Product change notification (PCN)

Title / short description Packaging change
Affected article category System cabling for controllers
Change category Form and appearance
Change number CCK230129-00
Reason for PCN/PDN Revision

VIP Screw and VIP PT Packaging change

Current packaging with dunnage and box

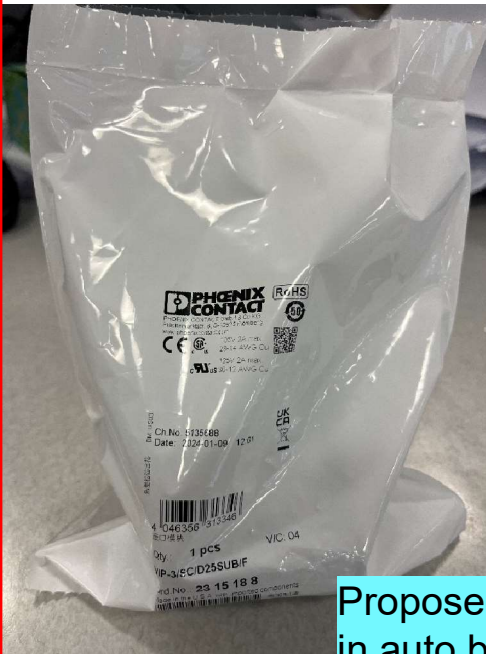
"As part of the continuous improvement process and to promote sustainability, the packaging of the VIP PT and VIP Screw modules containing 10 or less slices will be changed from a box/dunnage configuration to an autobag. A drop test was performed with a a basic function test and a mechanical visual inspection completed after the test. Conclusion: Passed
 Change will be a running change as inventory is depleted of boxed product and production transitions to bag."

Product packaged in plastic bag with printed label and heat sealed.

Proposed packaging in auto bag
